VALUE ENGINEERING CHANGE PROPOSAL MISSOURI DEPARTMENT OF TRANSPORTATION

Date 4/19/10
Contract ID 100122-202	Job No. <u>J2P0779C</u>
County RANDOLPH	24 Original Bid Cost \$ 2,012,213.80
Contractor APAC-MISSOURI, INC.	By DAVID B. TAG, P.E.
Designed By _APAC-MISSOURI, INC.	Phone (573) 449-0886
VECP# 10-44 (to be completed	by C.O.) VECP or VECP/PDU
The current plan is to perform the u 4 separate 5-day periods. This VE closing the adjacent section of Busadvantages of this are labor and eque coldmilling, geotextile, and overlay weeks to 2 weeks. The disadvantage	and proposed change(s). Advantages/Disadvantages inbonded overlay of the Bus. 367 24 intersection is 4 stages over Proposal is to perform the overlay in 2 stages rather than 4 by .63 while each half of Route 24 is being overlaid. The aipment savings by combining two activities into one for the y. Also, the total duration of the project will be reduced from 4 ges are a road closure that limits local access to Route 24.

Job No. J2P0779C & J2P0779D

THIS VE SIMPLIFIES TRAFFIC CONTROL BY SPLITTING
THE WORK INTO HALVES, INSTEAD OF QUARTERS, AND
REDUCING THE WORK SCHEDULE. CLOSURE OF BUS 63
WILL BE NECESSARY DURING CONSTRUCTION, HOWE

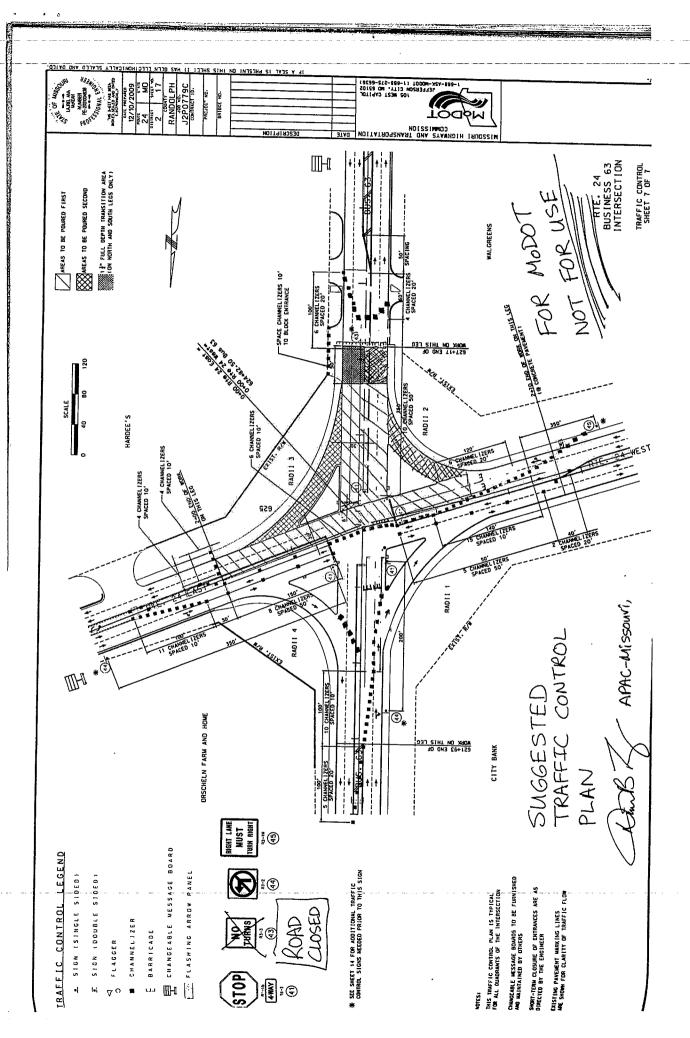
- Remove the traffic control or switch the traffic control to the next half open new concrete to traffic
- 4) I do not anticipate any additional signs or traffic control devices necessary for the work area. Simply put, the only modification to the traffic control plan will be to not allow right turns into the work area from Route 24 or through traffic on Bus. 63 into the work area. This will be done with channelizers and barricades in nearly the same configuration. I have provided a sketch with this letter as a suggestion, but the traffic control plan to be used must be provided by MoDOT.
